PURPOSE: To announce the change in the number of ignition attempts before a Code 11 (SENSEI™) or Code 110 (I-Series) error is displayed.

- Applicable Product: All SENSEI™ Tankless Water Heaters and I-Series Boilers

New Sequence (18 Ignition Attempts)

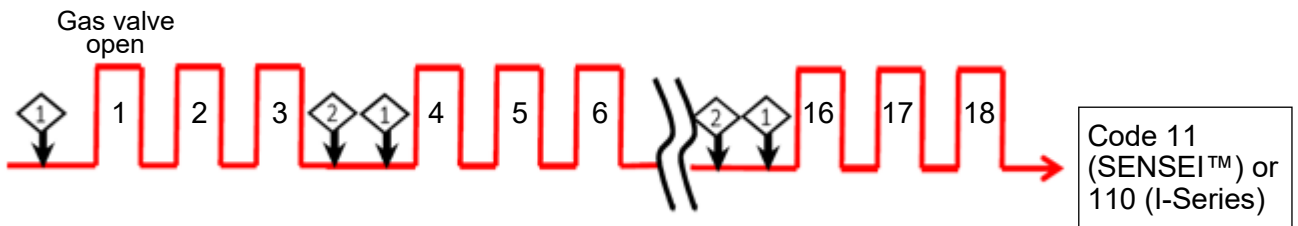
Currently, there are three ignition attempts on SENSEI™ and I-Series products before the unit displays a Code 11 (SENSEI™) or a Code 110 (I-Series). The SENSEI™ and I-Series software has been updated to increase the number of ignition attempts to 18 before the unit displays a Code 11 or Code 110. This software update will improve ignition performance by increasing the number of attempts to purge residual air that may exist in the gas line.
